**BEFORE THE BOARD OF PATENT APPEALS
AND INTERFERENCES**

Application Number: 10/820,931
Filing Date: April 08, 2004
Appellant(s): POND, GARY J.

EXAMINER'S ANSWER

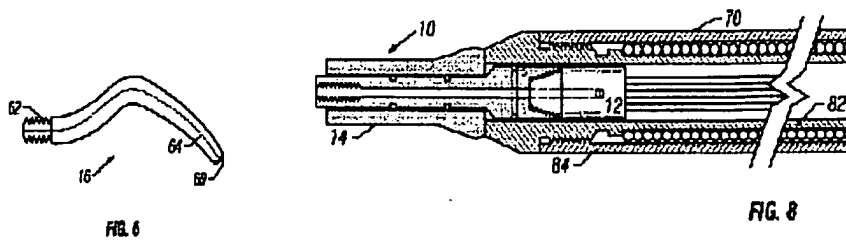
In response to rejection under 35 U.S.C. § 112 first paragraph, Appellant argues that the drawings (figures 4 and 7-11) provide adequate description for the phrase "unitary, one-piece

construction” of the elongated body. The examiner does not believe the drawings show sufficient detail to show such a construction of the elongated body part.

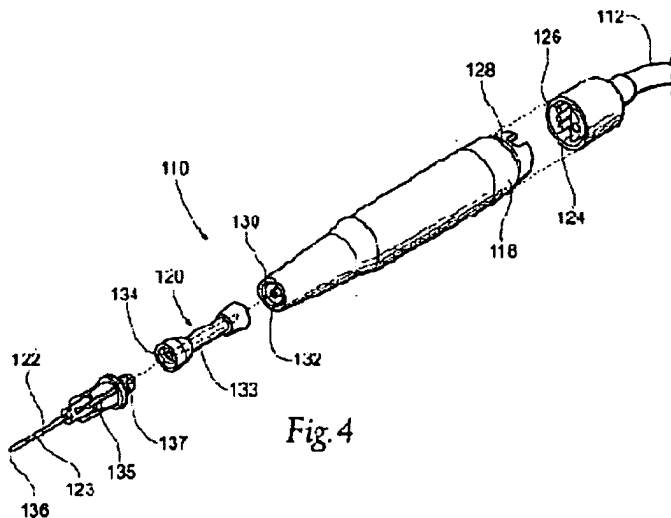
In response to rejection under 35 U.S.C. § 102(b), Appellant argues that Feine does not disclose an adaptor of unitary, one-piece construction and that Feine shows “a multi-part adaptor, with the main sections being shown as reference numeral #12, #14, and #16.” It is believed figure 4 of Feine shows the adaptor having unitary, one-piece elongated body not including the o-rings. Two of the three parts in Feine’s figures that the Appellant is identifying as parts of the “adaptor” are in fact the tip and handpiece (as shown, Examiner is calling the inner piece near #14 , the elongated body).

Appellant's figure can also be identified as having similar three-parts #122, #120, and #112, reference numbers as defined on page 3 of brief (see below).

In response to rejection under 35 U.S.C. § 103(a), Appellant argues that neither Feine nor Sharp discloses a dental adaptor being of unitary, one-piece construction. As stated above, it is believed figure 4 of Feine shows the adaptor having unitary, one-piece elongated body not including the o-rings. For that matter, Sharp shows a unitary, one-piece elongated body 18. However, it is noted that the elongated body part is claimed as unitary, one-piece construction, not the adaptor. The claim reads the adaptor further comprising means for restricting ultrasonic vibrations to said tip, which Sharp shows in column 5 line 32. The specification does not describe the elongated body or the restricting means of unitary, one-piece construction.
